STATE OF DELAWARE
EXECUTIVE DEPARTMENT
OFFICE OF MANAGEMENT AND BUDGET
STATE PLANNING COORDINATION

RE: PLUS review – PLUS 2006-12-07; Brekenridge

Thank you for meeting with State agency planners on January 3, 2007 to discuss the proposed plans for the Breckenridge project to be located On Indian Point Road between Andrews Lake Road and Route 15 (Canterbury Road). According to the information received, you are seeking site plan approval for 295 residential units on 124 acres.

Map of Brekenridge (PLUS 2006-12-07) Excellent ground-water recharge potential area is highlighted in green. The parcel under review is outlined in red.

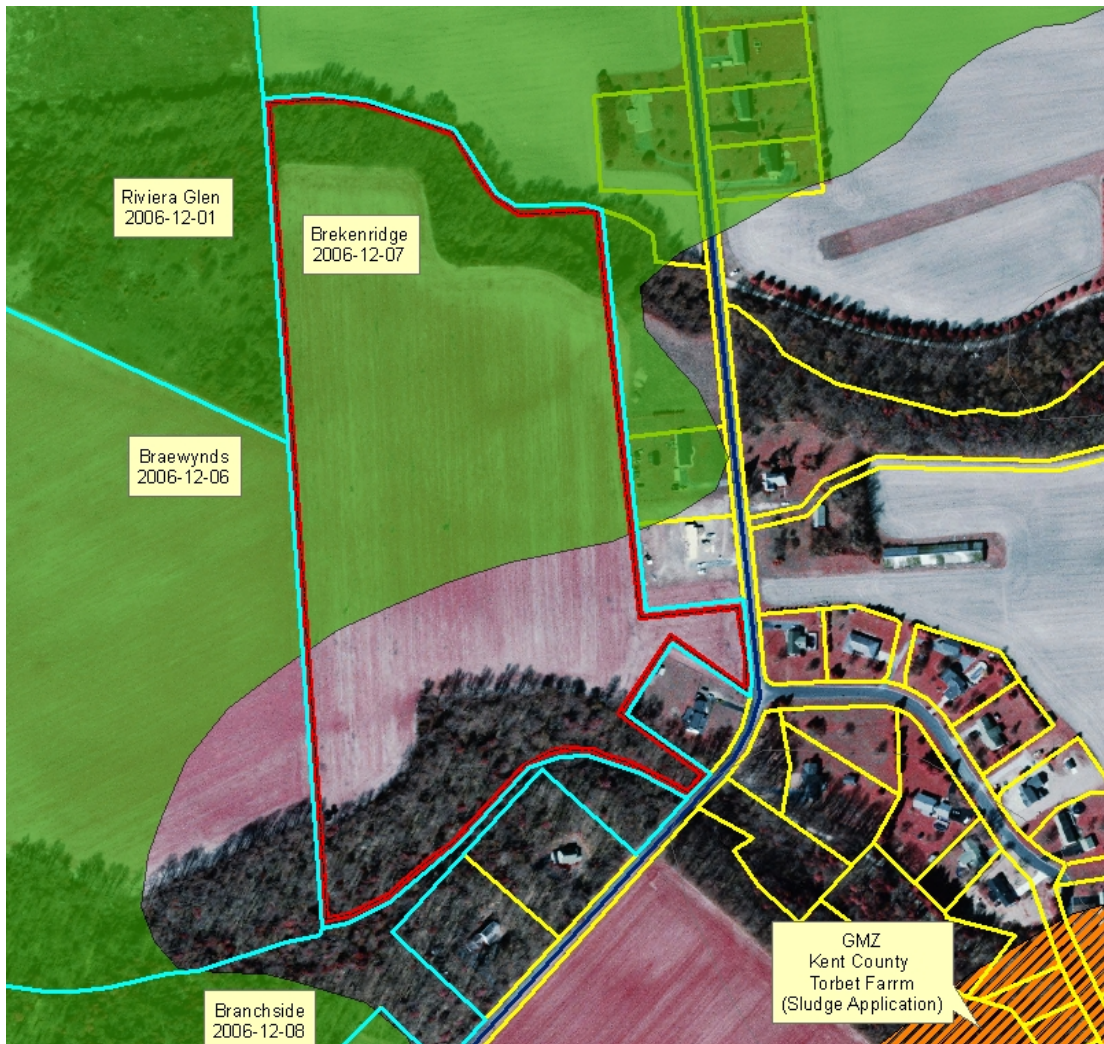
The Water Supply Section has determined that a significant portion of the site falls within an excellent ground-water recharge area for the Kent County (see following map and attached map). The site plans show storm water management ponds in the area of excellent recharge.

The construction phase of storm water management ponds requires excavation, hauling, and grading. The heavy equipment used in this phase has the capacity to compact and degrade the structure of the strata that defines the area as an excellent ground water recharge area. Changes to the structural soil properties may cause significant reduction in recharge capacity. Installing storm-water management ponds in excellent ground-water recharge areas has the potential to contaminate the ground water beneath it and infiltrate into the aquifer. Source Water suggests moving the storm water management ponds to an area of the site not on the excellent ground-water recharge area.

The Water Supply Section recommends that the portion of the new development within the excellent ground-water recharge area not exceed 20% impervious cover (DNREC, 2005). The purpose of an impervious cover threshold is to minimize loss of recharge (and associated increases in storm water) and protect the quality and quantity of ground water and surface water supplies.

The proposed development would change the impervious over from 0 % to approximately 8.1 %. Developer on the PLUS application provided these numbers. Ideally, relocating any open space areas to the part of the parcel within the excellent ground-water recharge area would decrease the total impervious area. Augmenting the groundwater recharge with clean rooftop run-off systems are another alternative to maintaining the quality and quantity of water recharging the aquifer (Kauffman, 2005).
